## Office Action Summary

This is the second office action for application number 10/659,731, Work Stand, filed on September 10, 2003.

Claims 1-4, 6 and 7 are rejected under 35 U.S.C. 102(b) as being anticipated by U.S. Patent number 2,675,981 to Ferris.

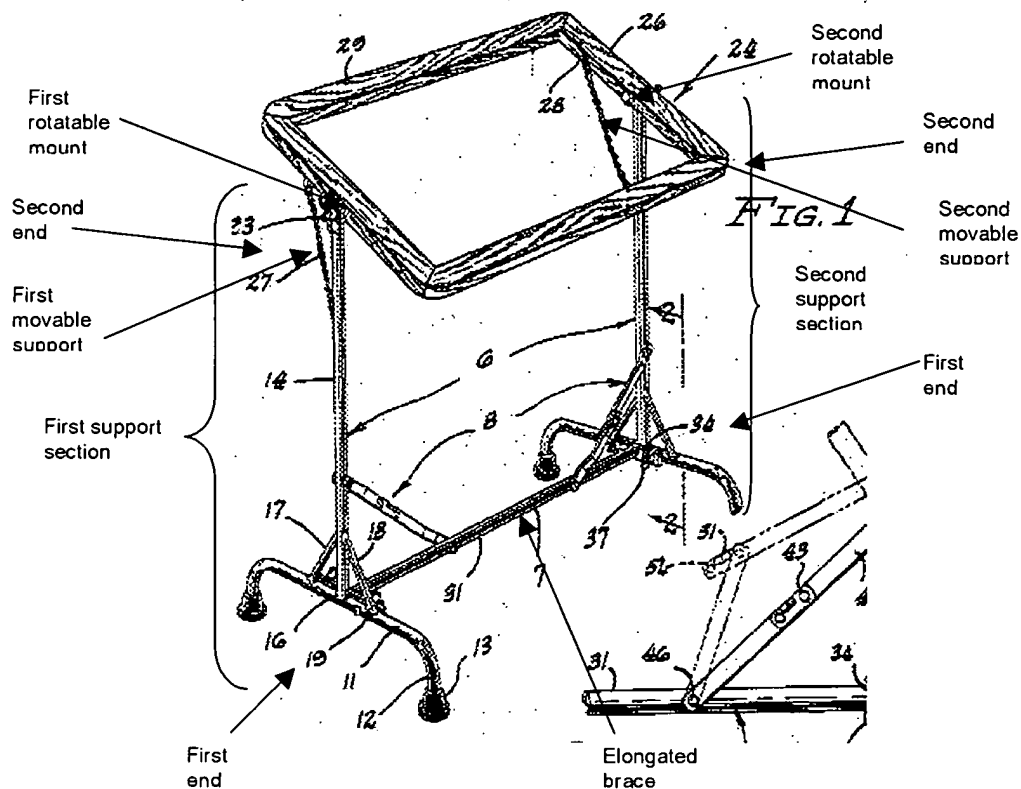
Ferris '981 discloses a stand (above) comprising first and second support sections (above) each having first and second ends, a first rotatable mount (above) disposed upon the first support section proximate to the second end thereof ("proximate" is defined in Merriam Webster's Collegiate Dictionary - 10<sup>th</sup> Edition as being "close," so clearly, the first rotatable mount is disposed "close" to second end of the first support section; further, all subsequent uses of the term "proximate" in this office action will use the same meaning, and all features being compared as "proximate" are clearly "close" to one another), a second rotatable mount (above) disposed upon the second support section proximate to the second end thereof, an elongated brace (above) having a first end (left end of elongated brace above) attached to/disposed on the first support section proximate to the first end thereof and a second end (right side of elongated brace above) attached to/disposed on the second support section proximate to the first end

thereof, a first movable support (above) disposed upon the first support section proximate to the first rotatable mount and beneath the first rotatable support, a second movable support (above) disposed upon the second support section proximate to the second rotatable mount and beneath the second rotatable mount.

Ferris '981 discloses the previous invention wherein it appears the first and second movable mounts are respectively mounted on the inside or outside of the first and second support sections, but it is not completely clear whether they are in fact mounted on either the inside or the outside of the support sections. It would have been obvious to one of ordinary skill in the art at the time the invention was made to have respectively mounted the first and second movable mounts on the inside or outside of the first and second support sections so as to either provide easier access to the movable mounts (if mounted on the outside) or to provide greater concealment of the movable mounts for aesthetical reasons (if mounted on the inside). Further, either configuration would provide sufficient support of an object utilizing the stand.

Finally, on page 16, the applicant for some reason maintains that the movable chain is not mounted on “any conceivable interior or exterior of the support,” and further, that there is no motivation to do so. The Examiner disagrees. With reference to figure 1 of Ferris ‘981, it appears that the movable supports are in fact mounted on either the exterior or interior of the supports, and it would be obvious to mount the movable supports on either the exterior or interior of the supports for reasons as previously described.

Claims 1-4 and 10-12 are rejected under 35 U.S.C. 102(b) as being anticipated by U.S. Patent number 5,046,203 to de Cuadros.

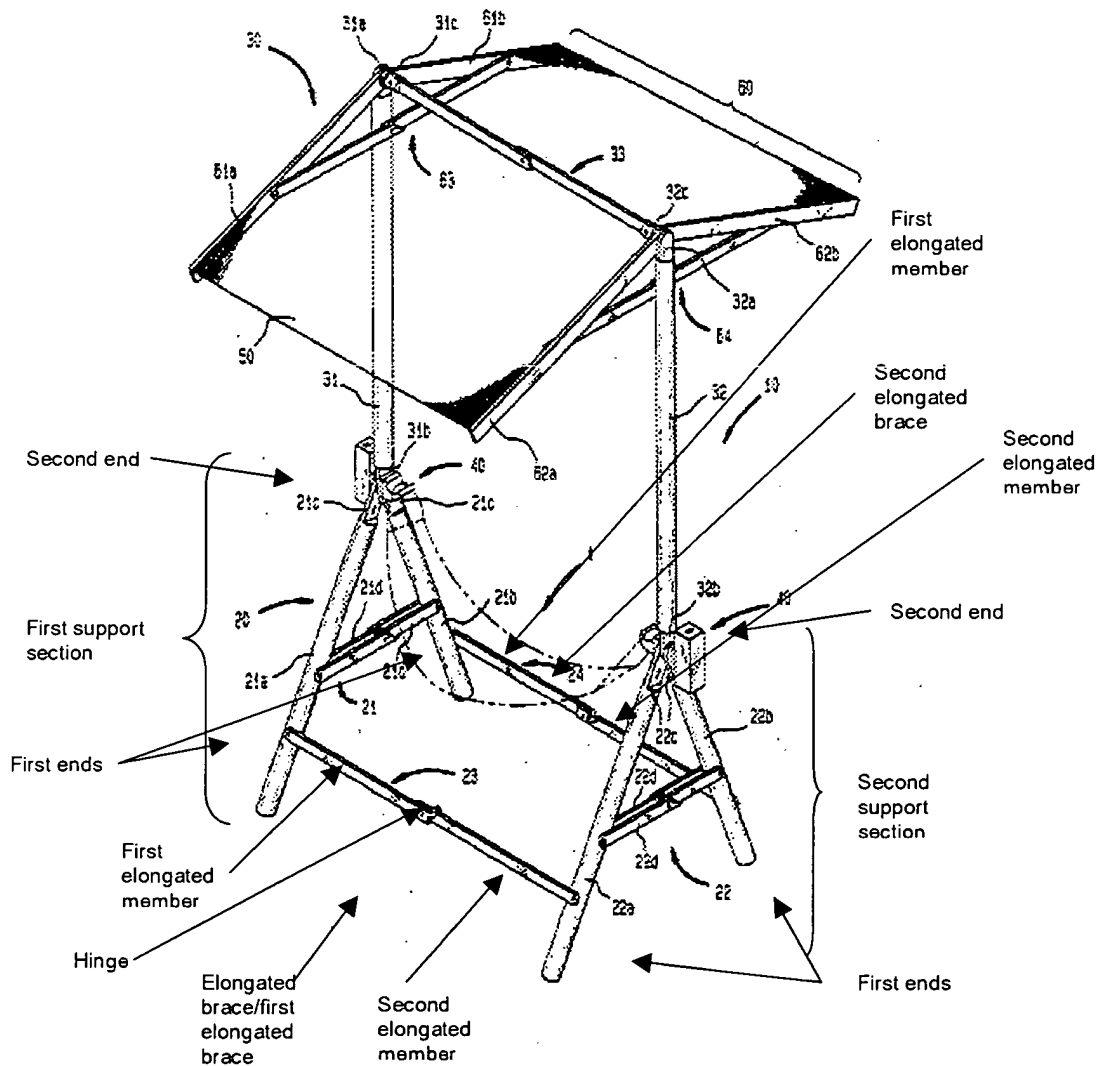
Regarding claims 1-4, 10 and 11, de Cuadros '203 discloses a stand (above) comprising first and second support sections (above) each having first and second ends, a first rotatable mount (41, it can rotate about the threads) disposed upon the first support section proximate to the second end thereof, a second rotatable mount (41, it can be rotated about the threads) disposed upon the second support section proximate to the second end thereof, a first movable support (31,31b, see column 3, lines 2-3, "pivotally") disposed upon the first support section proximate to the first rotatable mount, an elongated brace (above) having a first end (left end of elongated brace above) attached to/disposed on the first support section proximate to the first end thereof and a second end (right side of elongated brace above) attached to/disposed on the second support section proximate to the first end thereof, wherein the elongated brace further comprises a first elongated member (above) having first and second ends (left and right sides respectively, above), and a second elongated member (above) having first and second ends (right and left sides respectively, above), whereby the first end of the first elongated member is pivotally attached to the first support section proximate to the first end of the first support section, the first end of the second elongated member is pivotally attached to the second support section proximate to the first end of the second support section, and the second end of the first elongated member is pivotally attached to the second end of the second elongated member, wherein a hinge (above, 33f, see column 3, lines 35-52).

Further, regarding claim 12, de Cuadros '203 teaches the first support section to have first and second legs (21a,21b) each having first and second ends (above), wherein the second ends of the first and second legs are substantially together and the first ends of the first and second legs are substantially apart, and the second support section to have first and second legs (22a,22b) each having first and second ends (above), wherein the second ends of the first and

wherein the stand further includes a first support brace (21d) having a first end connected to the first leg of the first support section proximate to the first end of the first leg of the first support section, and the second end of the first support brace is connected to the second leg of the first support section proximate to the first end of the second leg of the first support;

wherein the stand includes a second support brace (22d) having a first end connected to the first leg of the second support section proximate to the first end of the first leg of the second support section, and the second end of the second support brace is connected to the second leg of the second support section proximate to the first end of the second leg of the second support section;

wherein the above mentioned elongated brace is a first elongated brace, wherein the first elongated member of the first elongated brace has a first end pivotally attached to the first leg of the first support section proximate to the first end of the first leg of the first support section, wherein the first end of the second elongated member of the first elongated brace is pivotally attached to the first leg of the second support section proximate to the first end of the first leg of the second support section, and the second end of the first elongated member of the first elongated brace is pivotally attached to the second end of the second elongated member of the first elongated brace,

wherein the stand further includes a second elongated brace (above), wherein a first elongated member of the second elongated brace has a first end pivotally attached to the second leg of the first support section proximate to the first end of the second leg of the first support

section, wherein the first end of a second elongated member of the second elongated brace is pivotally attached to the second leg of the second support section proximate to the first end of the second leg of the second support section, and the second end of the first elongated member of the second elongated brace is pivotally attached to the second end of the second elongated member of the second elongate brace.
